**REQUEST FOR AMENDMENT TO TECHNICAL SPECIFICATIONS
TO INCREASE POWER LEVEL FROM 3323 MWt TO 3486 MWt,
SUPPLEMENTARY INFORMATION**

Attachment 3
Page 1 of 17

**TECHNICAL SPECIFICATION PAGES
and BASES CHANGES**

Figure 3.2.6-1

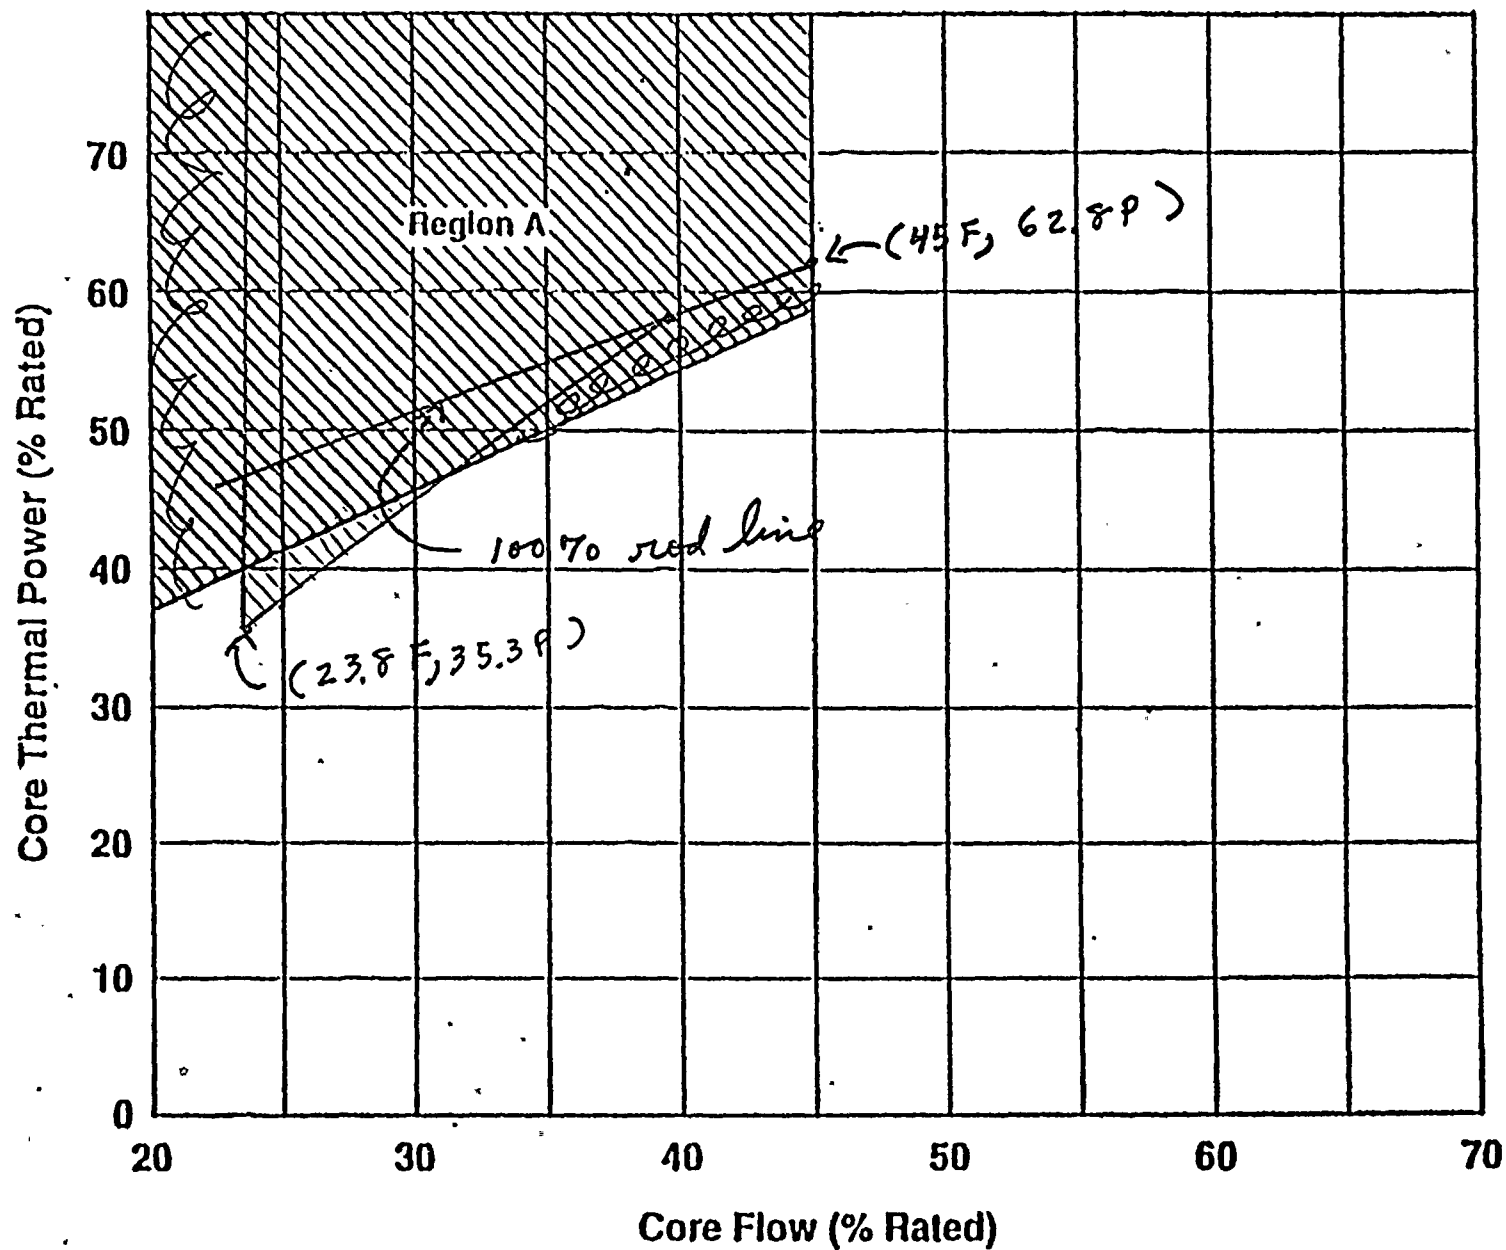
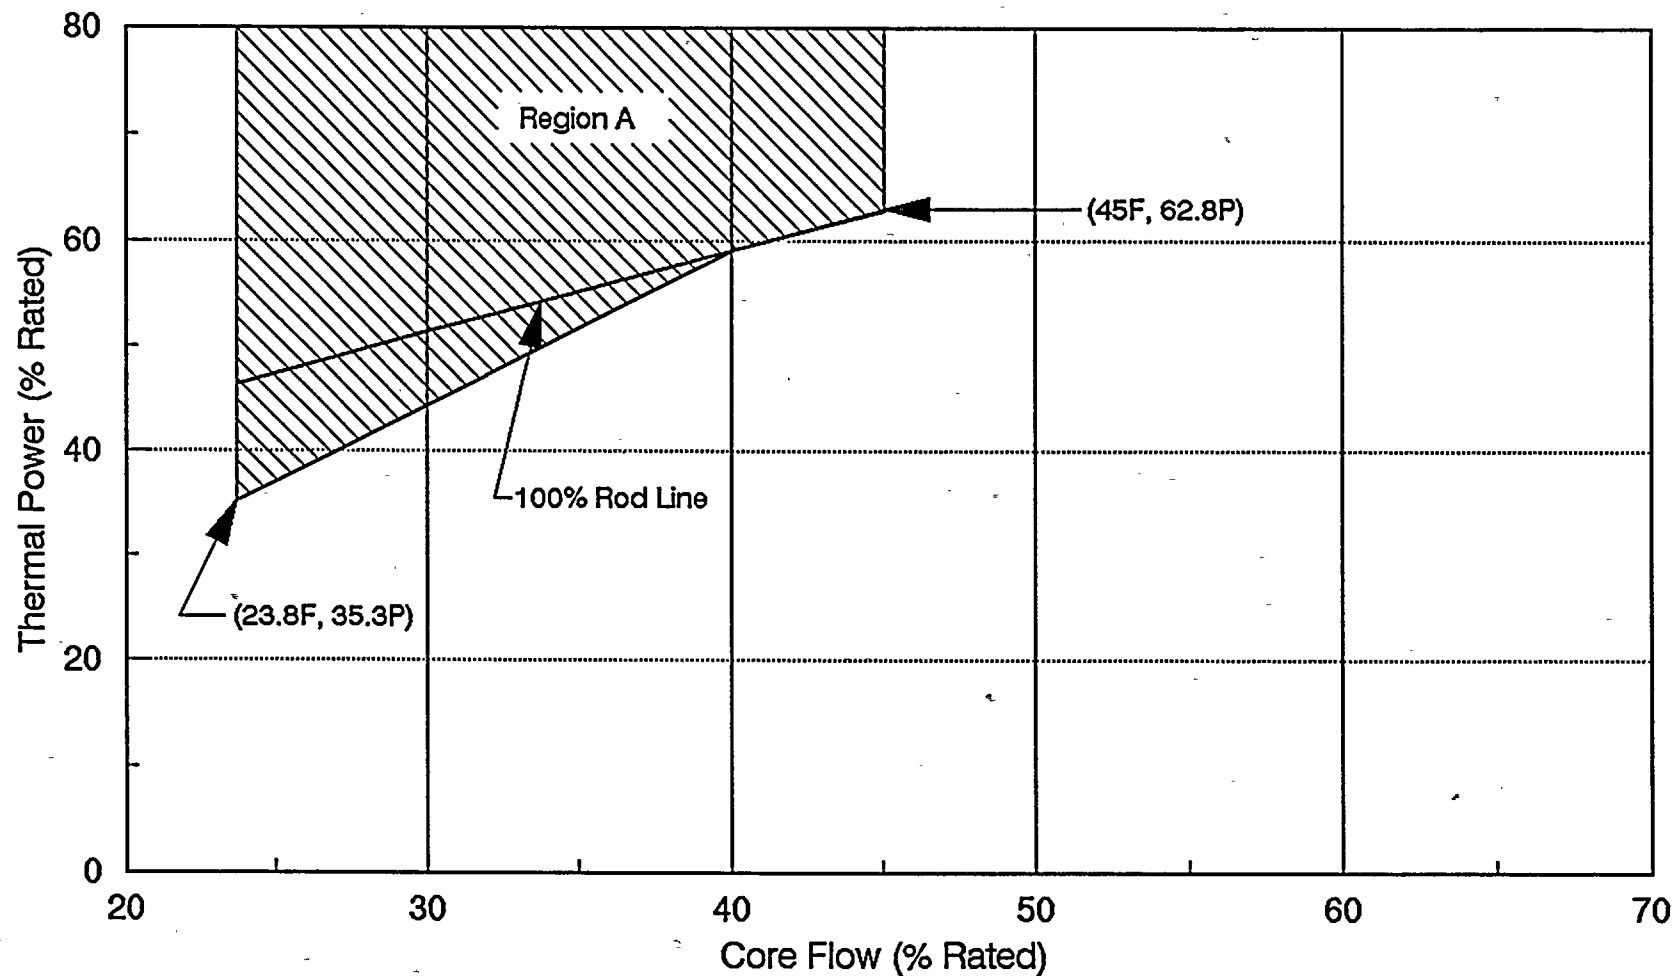
Two power/flow maps are provided for Figures 3.2.6-1, 3.2.7-1, 3.2.8-1, and 3.4.1.1-1. The first map reflects the present Technical Specification power/flow map with the proposed changes superimposed for comparison and the second shows only the proposed power/flow map.

APPLICABILITY: OPERATIONAL CONDITION 1, when THERMAL POWER is greater than ~~39%~~ of RATED THERMAL POWER and core flow is less than or equal to 45% of rated core flow.

35.3%

Reviewer: Please note that this value comes directly from the proposed power flow map 3.2.6-1.

3.2.6 Operation with THERMAL POWER/core flow conditions which lay in Region A of Figure 3.2.6-1 is prohibited.

The stability REGIONS A and B are shown in Figure 3.2.6-1. REGION A conforms to the recommendations of SIL 380 in that REGION A bounds a calculated decay ratio of 0.9. Operation in REGION A is prohibited. REGION C bounds a decay ratio of 0.75.

Figure 3.2.8-1

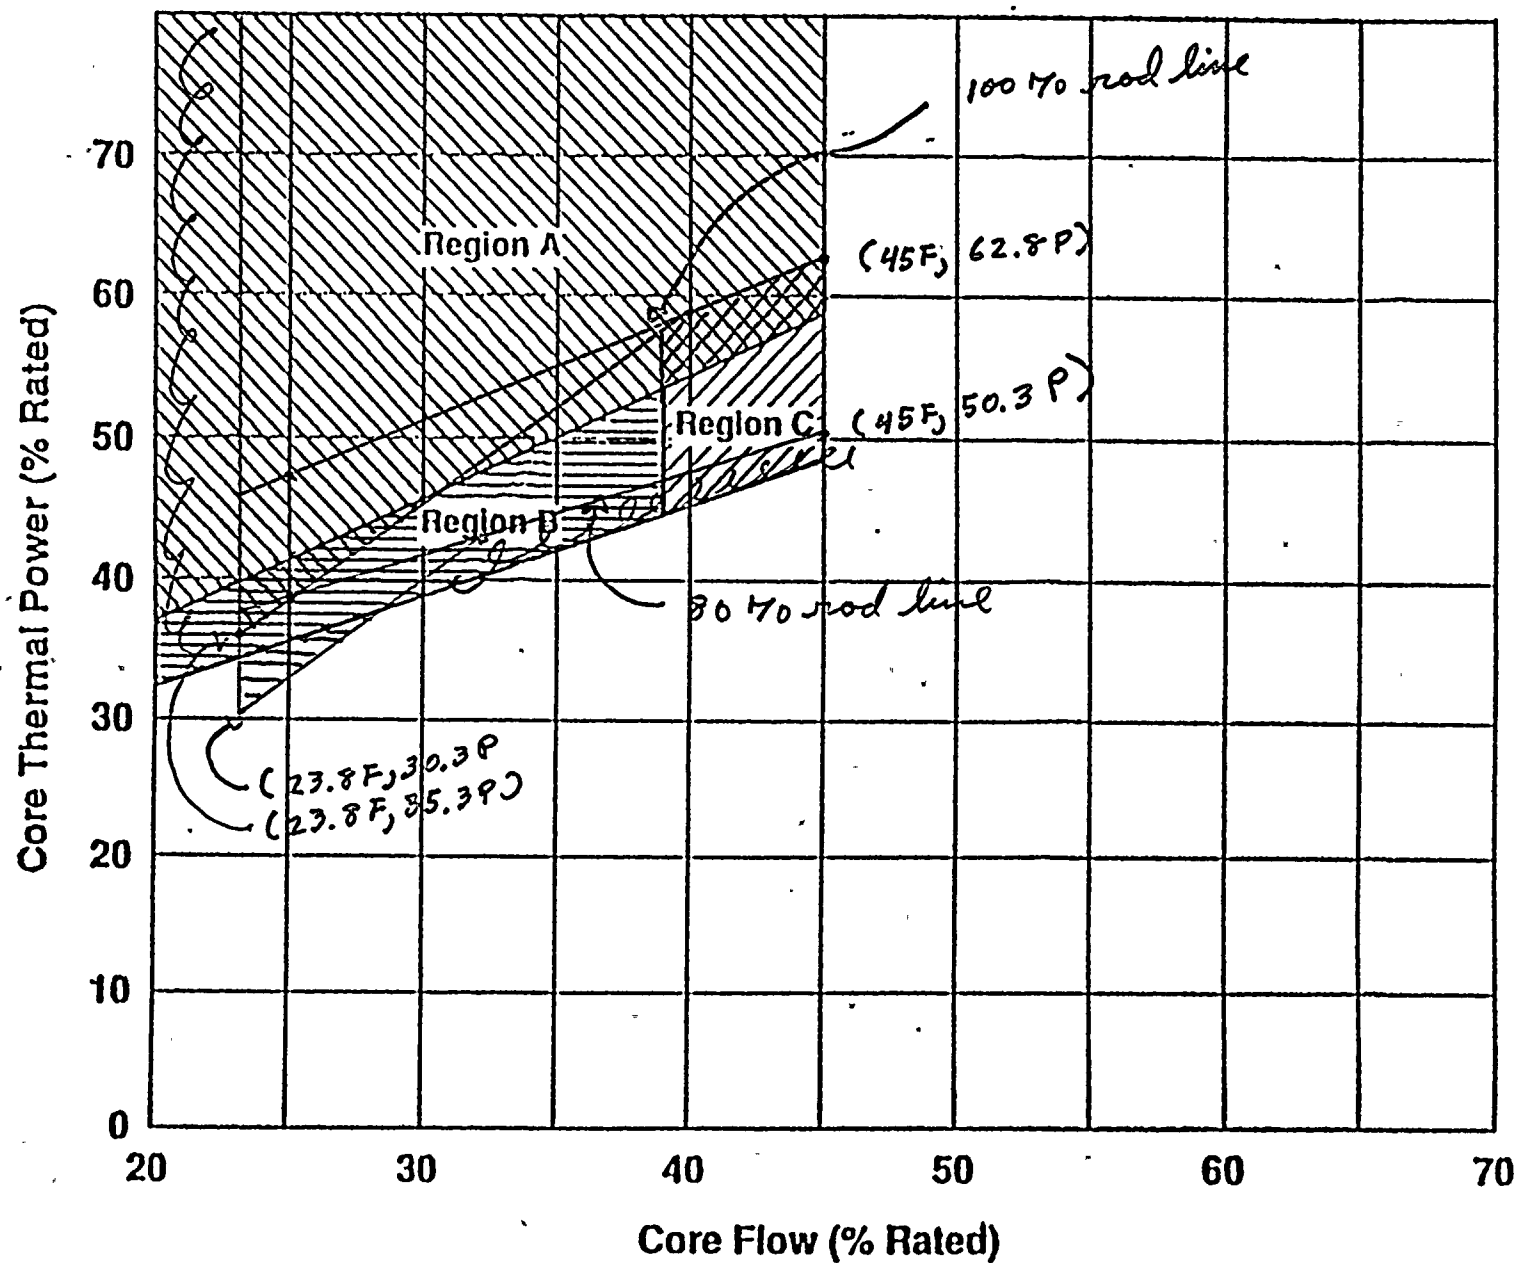
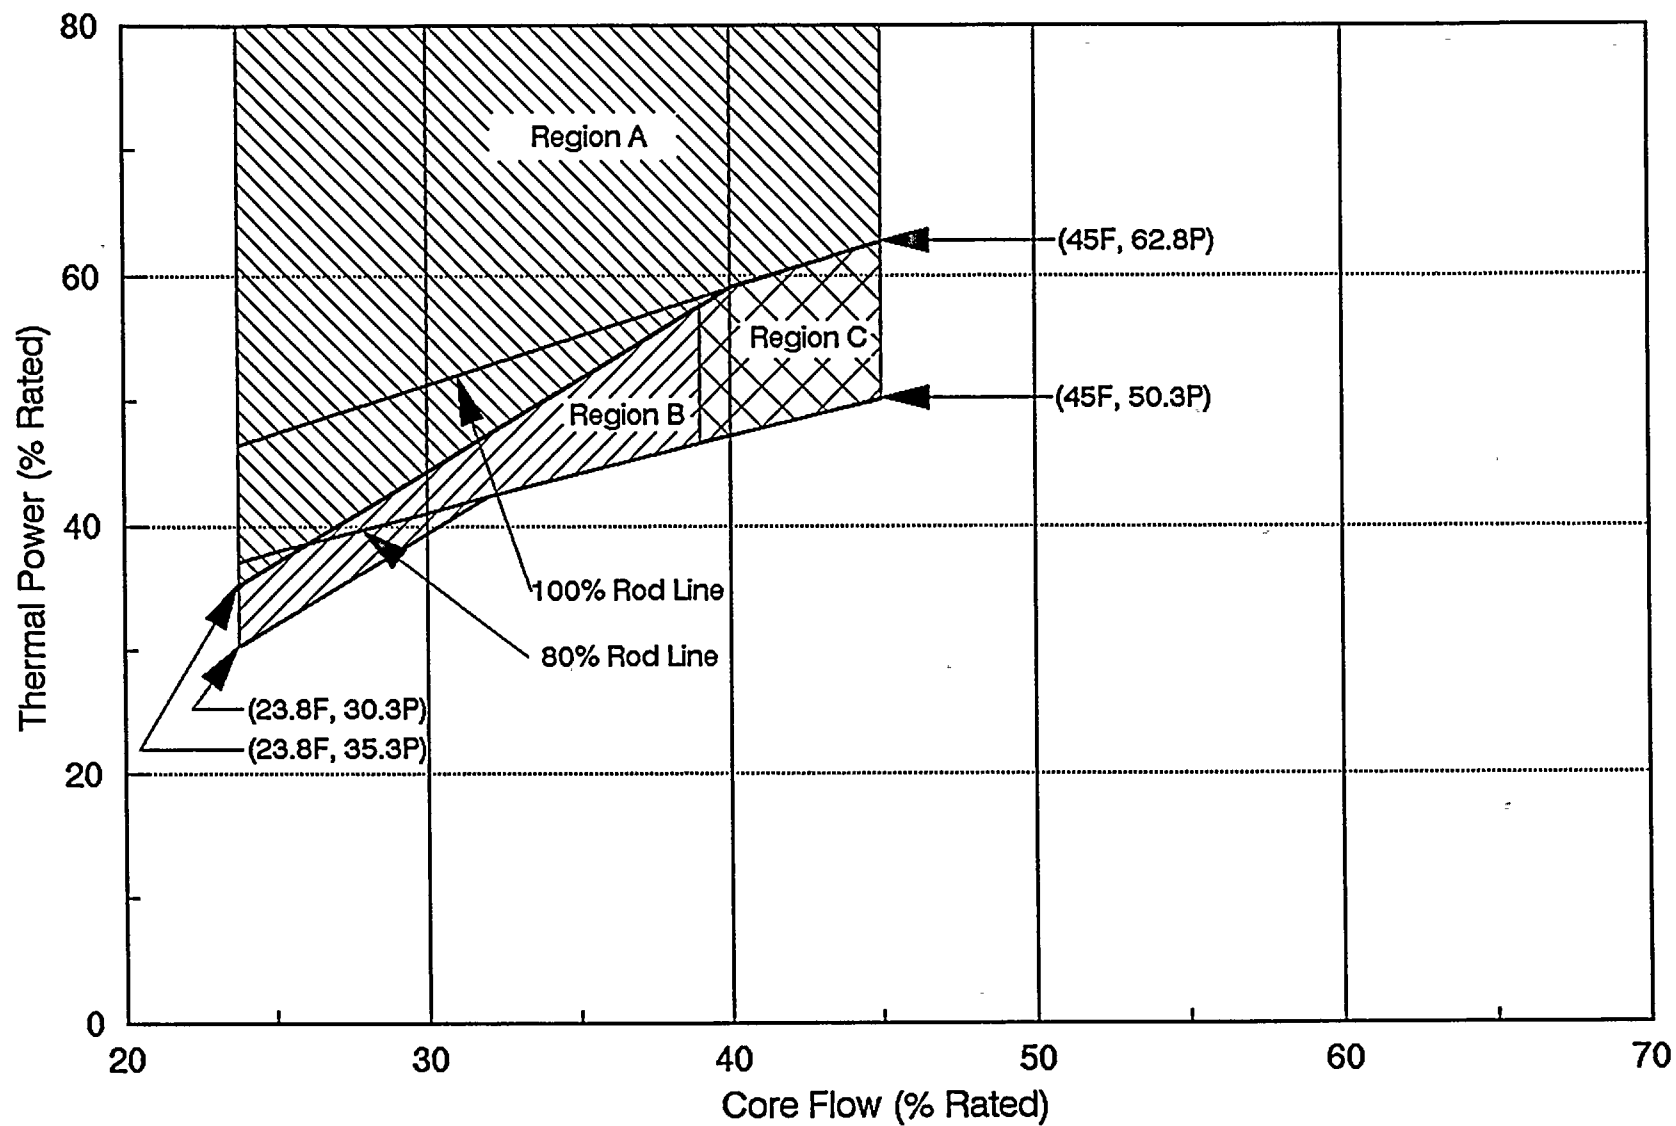
- a. With decay ratios of any two (2) neutron signals greater than ^{or equal to 0.75} .75 or with two (2) consecutive decay ratios on any single neutron signal greater than .75:

^{or equal to 0.75} As soon as practical, but in all cases within 15 minutes, initiate action to reduce the decay ratio by either decreasing THERMAL POWER with control rod insertion or increasing core flow with recirculation flow control valve manipulation. The starting or shifting of a recirculation pump for the purpose of decreasing decay ratio is specifically prohibited.

APPLICABILITY: OPERATIONAL CONDITION 1, with one recirculation loop in operation and THERMAL POWER/core flow conditions which lay in Region C of Figure 3.2.8-1.
